Historical Architectural Review Board
COA Preliminary Review Sheet

HDC-2024-00094

Address: 728 Liberty Street

Proposal: Solar Panel Installation

Proposed Attachment Details (Applicant)

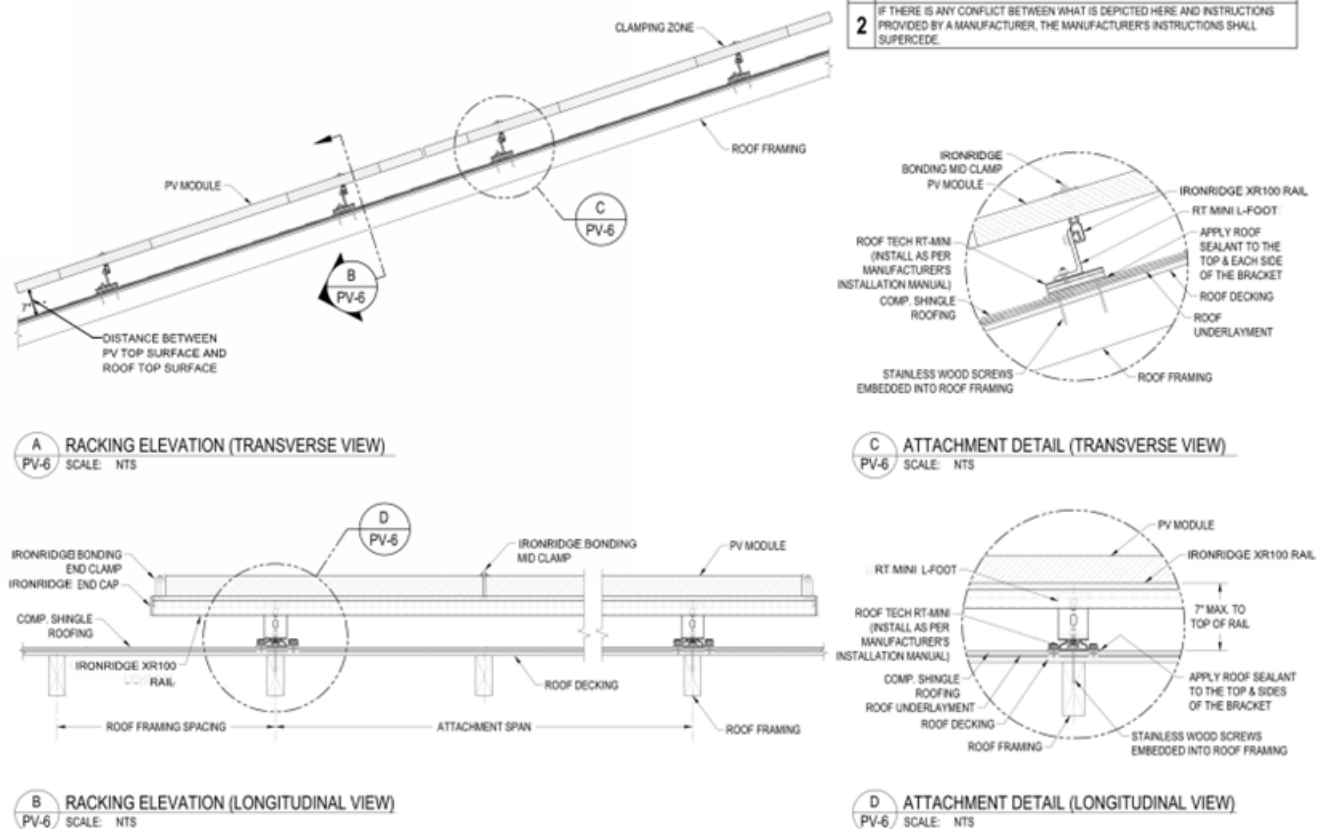
- In the submitted drawings, the "top rail" does not appear to align with the top of the solar panel itself. What is the expected total height of the system from the surface of the existing roof?
- Was there consideration for installing panels on the rear slope of the roof only?

Discussion: The applicant noted they submitted revised plans for the project that address some of the staff recommendations related to the visibility of the panels from the front of the structure. They reduced the number of panels from 24 to 15. The applicant noted 6" is the distance between the roof and panels (7" is the maximum distance permitted.) They are also proposing to move the electrical equipment indoors to the basement, instead of at the northeast corner of the property on the exterior. The applicant would like to know if solar panels are acceptable on the front slope of the building; the applicant thinks visibility will be minimal, due to the footprint of the building. The power disconnect will be located on the exterior of the building per NEC rules and the conduit will run up the side of the house. Mr. Huber noted that the preference would be to run this on the back of the house, which is not visible from the right-of-way. The applicant noted that they will also replace the roof to provide a solid foundation for the panels. Mr. Jordan asked what the existing roof material is; it was noted that slate is the current material that will be replaced with shingles. It was noted that roof replacement was not part of the application, so a separate application for the roof replacement will be needed.
